Town of Knightdale

Staff Report

Title: Lyndon Oaks Planned Unit Development (ZMA-2-23)

Date: June 10, 2024

April 18, 2024 Proposed Cross-Section

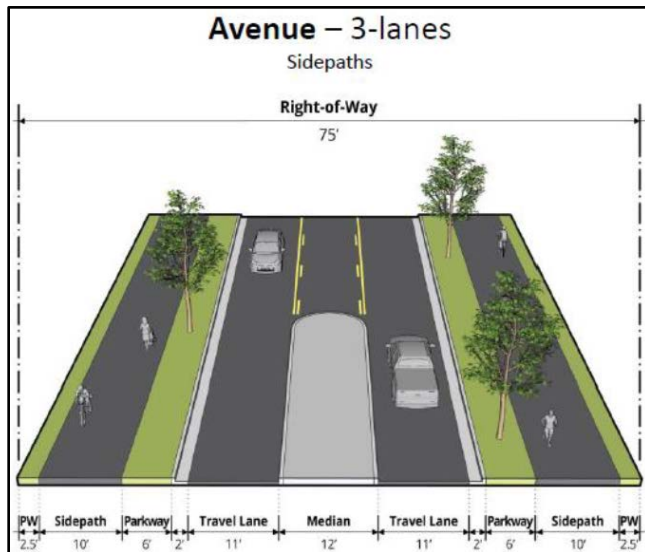
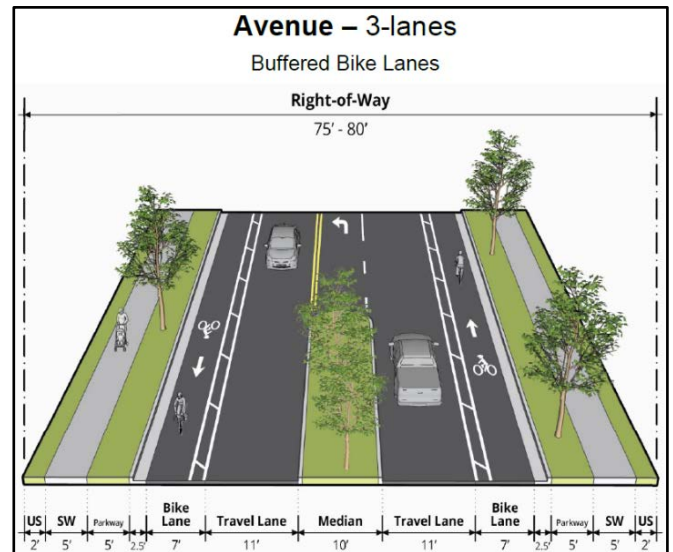
Staff Recommendation (April 18, 2024): Throughout the Master Plan review, staff informed the Applicant that the Comprehensive Transportation Plan (CTP) and UDO do not call for a sidepath along this portion of the Widewaters Parkway Extension, and therefore, the Avenue – Sidepaths Cross-Section should not be constructed. Instead, it is staff’s recommendation to construct the Avenue – Buffered Bike Lane Cross-Section and explore the option of expanding the right-of-way from 75 feet to 80 feet to account for a ten-foot-wide sidepath on one side of the street.

Applicant Response: The proposed roadway cross-section for Widewaters Parkway and site design has been modified to comply with the CTP, UDO, and staff recommendations.

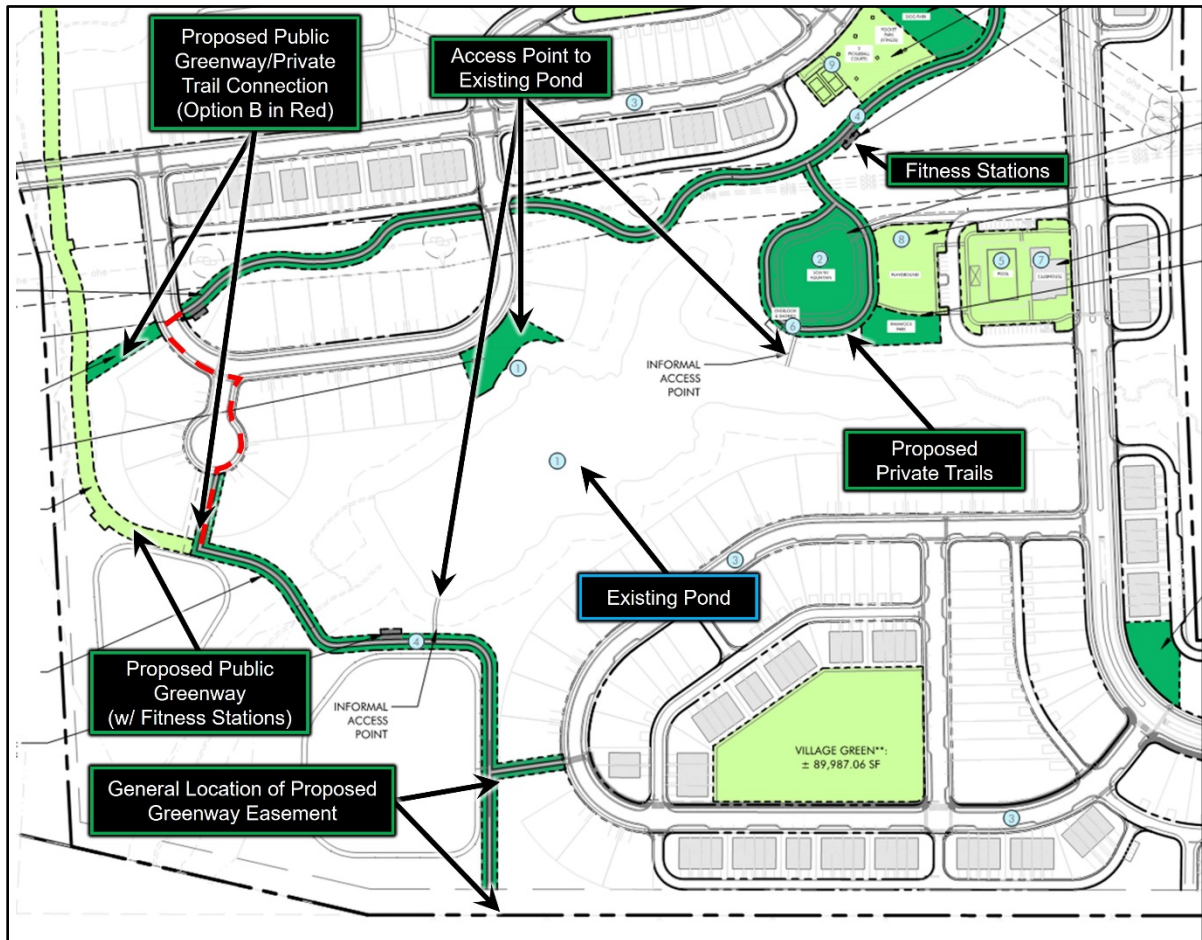
Staff Analysis (April 18, 2024): To increase pedestrian connectivity throughout the site, staff encourages the Applicant to continue to explore the feasibility of connecting the private trail network to the public trail network through the powerline easement that runs east to west along the middle of the site. Staff also encourages the Applicant to continue to explore the feasibility of adding a trail around the existing pond towards the south-central portion of the site. *Below graphic updated to reflect current proposal, which addresses staff comments.*

Applicant Response: The private trail network has been revised to extend through the powerline easement and connect to the proposed public greenway trail in the general location shown on the above graphic. The revised Master Plan also provides an Option B route (similar to the requested optionality for the public greenway corridor described on Page 17 of this Staff Report) for this private/public trail connection for consideration in case the environmental permitting through the United States Army Corps of Engineers (USACE) is not achievable based upon the developer's cumulative stream and wetland impacts across the entire site. A formal paved trail around the existing pond presents challenges in terms of environmental impacts and potential negative effects to the existing pond's stability. In lieu of a formal paved trail, the Applicant revised the Master Plan to include a passive open space area near the northwest portion of the pond so residents can still access the pond and enjoy its natural beauty (see above graphic).

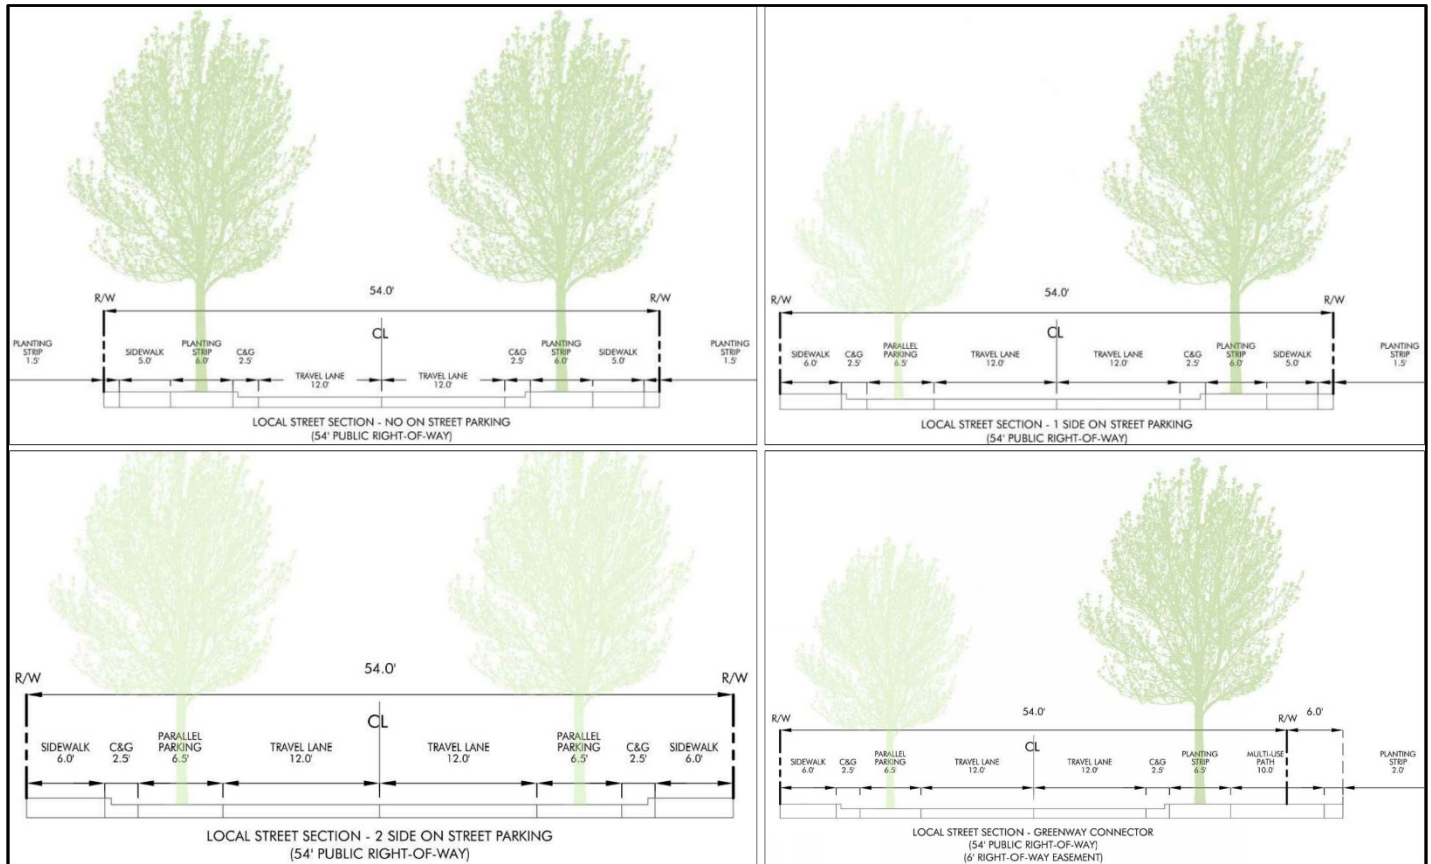
Staff recommend the Local Street Section – Greenway Connector cross-section is either expanded to a 60-foot-wide Public Right-of-Way so that all improvements are located within a single right-of-way (removing the need for a separate easement), or the multi-use path is shifted to be adjacent the curb & gutter, and the street trees are planted on private property (right-of-way width remains 54-foot-wide).

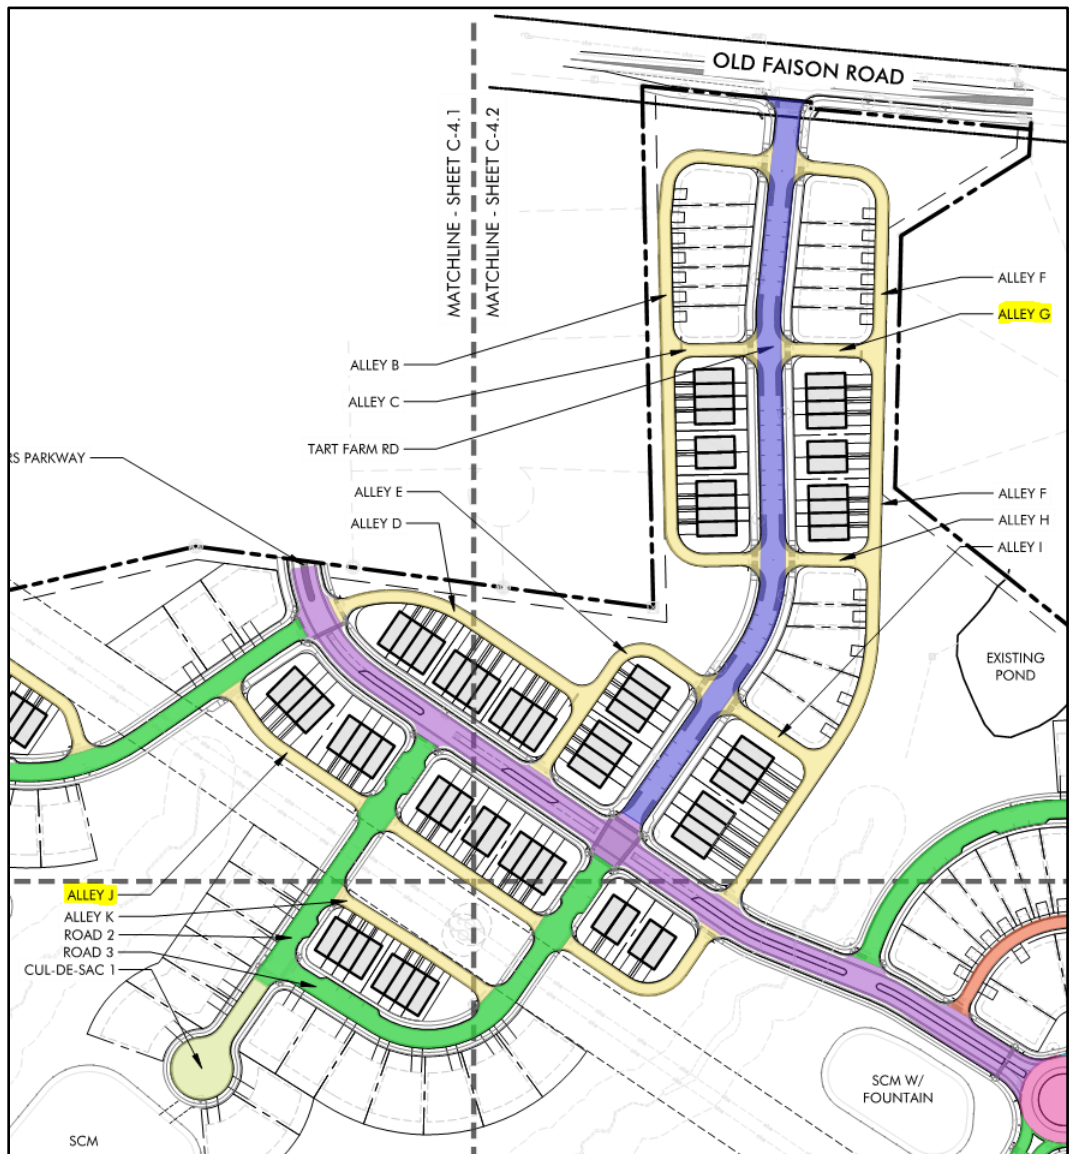
Staff Analysis (April 18, 2024): When a rear-loaded residential lot is served by an alley but is not adjacent to a public right-of-way (i.e. when open spaces separate the lot and right-of-way), modifications to the dedication type (private vs. public) and width are necessary to accommodate the installation of water and sewer infrastructure. Staff concurs that Alleys I, J, K, O, R, V, W,

Applicant Response: The dedication of Alley G has been revised to be a private alley. This alley has been renamed to Alley J on the revised Master Plan due to additional alleys being added along the main access road to Old Faison Road.

April 18, 2024 Proposed Design

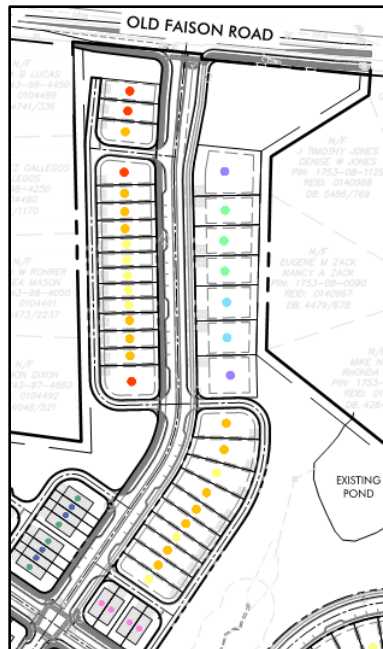
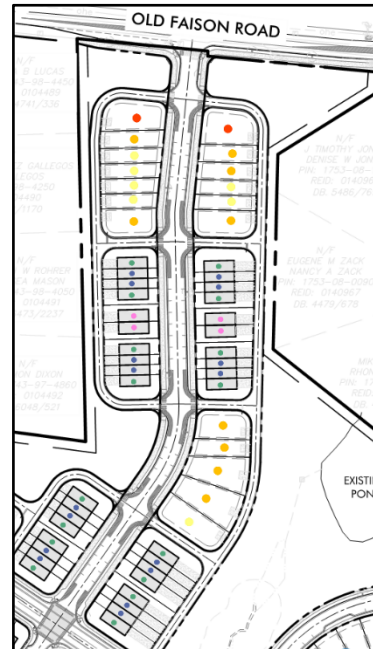
- **Requested:** The Applicant proposes a modified Main Street Cross-Section for the development's access drive (currently known as Tart Farm Road). The proposed design of this road meets the standards outlined in Section 7.2.A.2 of the UDO, except for the landscaped median. The Applicant proposes to remove this required median so that driveway and alley access are not restricted.

Applicant Response: *The design of this portion of the neighborhood has been revised to propose rear-loaded housing products rather than front- and rear-loaded housing products. The roadway design has also been revised to implement the Urban Main Street – Wide Sidewalk Cross-Section.*
